REQUEST

Proposed Zoning: R-17MF(CD) LLWPA (multi-family residential, conditional, Lower Lake Wylie Protected Area)

Approximately 28.05 acres located on the north side of Shopton Road, west of I-485.
 (Outside City Limits)

The petition proposes to allow a multi-family residential community on acreage located north of Berewick Town Center and Charlotte Premium Outlets, south of Berewick Regional Park, and west of Interstate 485.

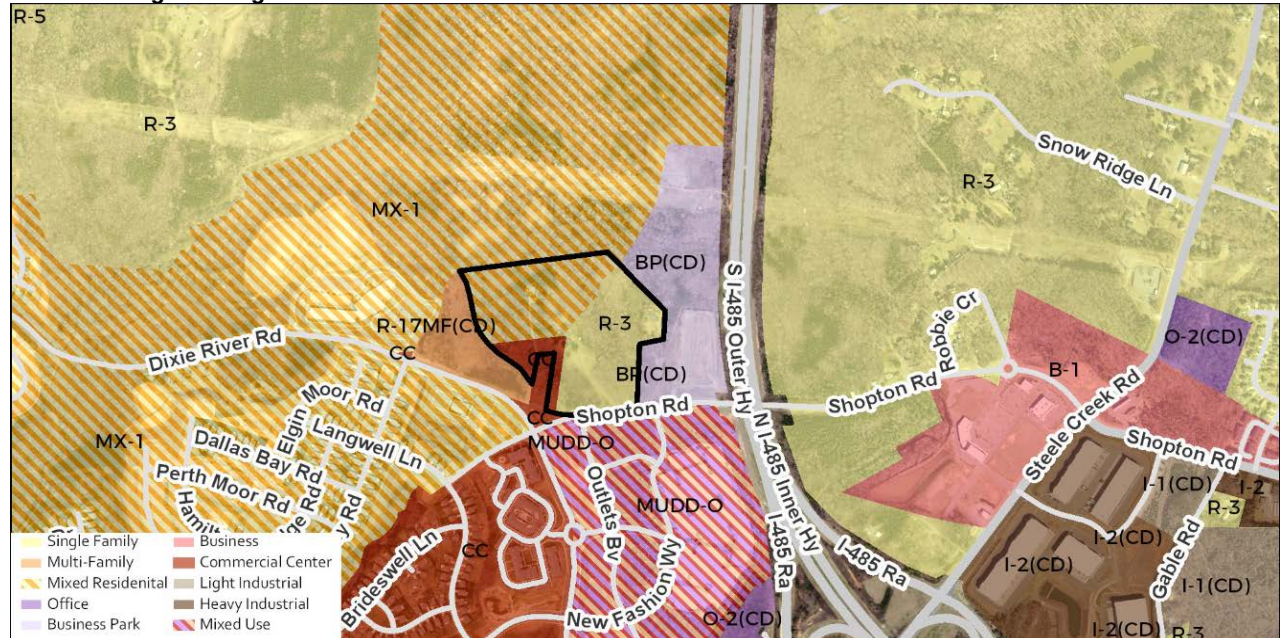
1. ~~Revise the site plan and conditional note to show Public Street A to be in alignment with the intersection of Outlets Boulevard and Shopton Road. Access may be restricted to right in/right out and would be determined during permitting in conjunction with NCDOT.~~ **Addressed**

2. ~~The entrance is to be gated as this is only an emergency access point.~~ **Addressed**
3. ~~Revise the site plan to show two curb ramps at the NE corner of Shopton Road and Dixie River Road and receiving curb ramps at the NW and SE corners of Shopton Road and Dixie River Road.~~ **Addressed**

4. ~~Revise the site plan to add a note specifying dedication and fee simple conveyance of all rights of way to the City before the site's first building certificate of occupancy is issued. CDOT requests right-of-way set at two feet behind back of sidewalk where feasible.~~ **Addressed**

5. The petitioner should revise the site plan to add a note specifying all transportation improvements will be approved and constructed before the site's first building certificate of occupancy is issued. The petitioner may phase transportation improvements if said improvements and phasing are explicitly described in site plan notes.

- a. Petitioner should revise the conditional note "d" under Transportation to "first" certificate of occupancy, instead of "last." The petition proposes 330 units with only one access point. All roadway improvements should be in place in order to support the amount of traffic generated by the site. **Not addressed. Note "e" under Access, Transportation, and Improvements should be changed to state "roadway improvements will be approved and constructed prior to the first building certificate of occupancy." The site only has one access point and will need transportation improvements in place in order to support the development.**

6. ~~Show tree save calculations clearly in table on site map.~~ **Addressed**
7. The petitioner shall submit a tree survey for all trees two inches in diameter at breast height (DBH) or larger located in the public right-of-way. In addition, the survey shall include all trees eight inches (DBH) or larger in the setback. Tree survey may be completed by landscape architect, surveyor, or other land development professional. **Not Addressed. The petitioner has added a note to the site plan indicating that a tree survey will be submitted as part of the land development permitting process for the Site. Not Addressed. Petitioner must submit survey prior to City Council decision.**

8. ~~Clarify the extension of sidewalk on Shopton Road to be from Dixie River Road to New Fashion Way.~~ **Addressed**
